Approval of Reserved Matters Consultation

Application Number: 243124

Site Address: Land At Bridge Farm, Bridge Farm Lane, Twyford, Berkshire

MEMORANDUM

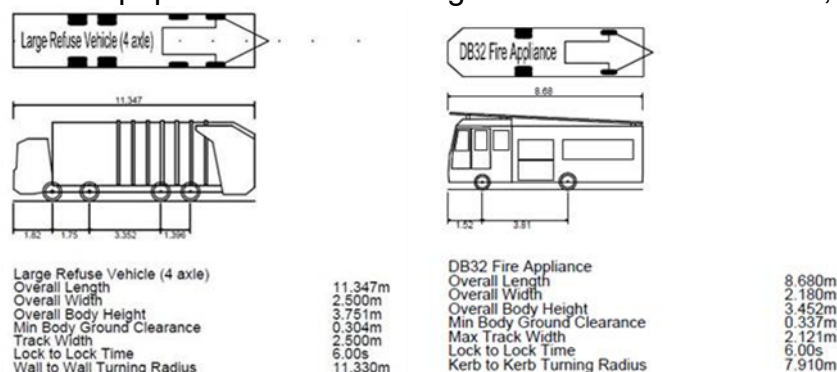
31. Drawing DES/703/109 Rev 1 has been submitted showing the extent of the site roads being offered for adoption which is welcome. **Highways would expect to see a drawing showing the roads being offered for adopted highlighted rather than just a light-coloured boundary.**
32. Once the comments on the swept paths have been satisfactorily responded too, highways would then be able to review the layout of the site roads.
33. Highways would have expected to see a service margin plan submitted as set out in the pre-application comments to the following standards, namely: -
- a. With frontages – 2m
 - b. With lighting and no frontages – 1m
 - c. With no lighting and no frontages – 0.5m
34. **A revised highway layout plan has been submitted however, it is not clear what the amendments are.**
